State of New Mexico
 Energy, Minerals and Natural Resources

SUNDRY NOTICES AND REPORTS ON WELLS (DO NOT USE THIS FORM FOR PROPOSALS TO DRILL OR TO DEEPEN OR PLUG BACK TO A DIFFERENT RESERVOIR. USE "APPLICATION FOR PERMIT" (FORM C-101) FOR SUCH PROPOSALS.)	
1. Type of Well: Oil Well ☐ Gas Well ☒ Other	
2. Name of Operator OXY USA WTP LP.	
3. Address of Operator 5 GREENWAY PLAZA, SUITE 110, HOUSTON TX 77046	
4. Well Location Unit Letter J : 2000 feet from the SOUTH line and 1650 feet from the EAST line Section 32 Township 21S Range 24E NMPM EDDY County	
11. Elevation (Show whether DR, RKB, RT, GR, etc.) 4214' GL

OXY respectfully requests approval to plug and abandon the subject well. See the attached proposed plugging plan, a current and proposed wellbore diagram for reference.

INDIAN BASIN 32 STATE #2

Current Wellbore

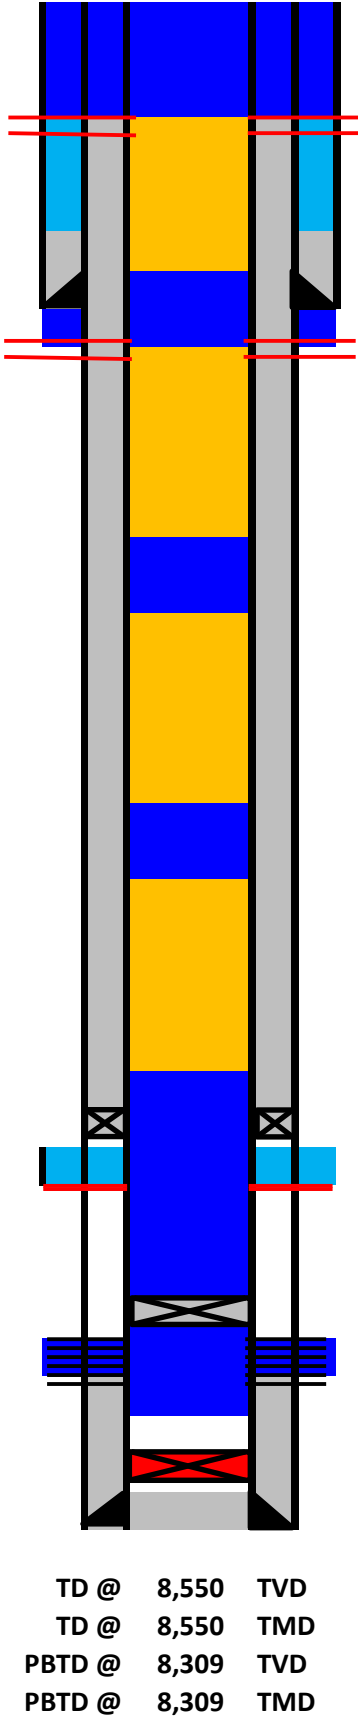
See Changes to Plugging Plan

NEW "2024" COA's

MUST BE PLUGGED BY 11/1/24

1. SET CEMENT RETAINER AT 7650'. SQUEEZE THROUGH RETAINER W/ 105 SX CLASS H CMT.
2. STING OUT OF RETAINER - Test casing and retainer 500psi/30min -bubble test - run CBL
3. SPOT 50 SX CLASS H CMT 7650'-7408'. WOC AND TAG. - T sqz perfs
4. SPOT 25 SX CLASS H CMT 7255'-7119'. WOC AND TAG. - T Wolfcamp
5. Spot 25 sx Cl C cmt @ 4200' - Spacer
6. SPOT 25 SX CLASS C CMT 2760'-2624'. WOC AND TAG.
7. PERF AT 1857'. SQZ W/ 55 SX CLASS C CMT 1857'-1757'. WOC AND TAG.
8. PERF AT 595'. CIRCULATE 300 SX CLASS C CMT 595'-SURF. WOC AND VERIFY CMT AT SURF.
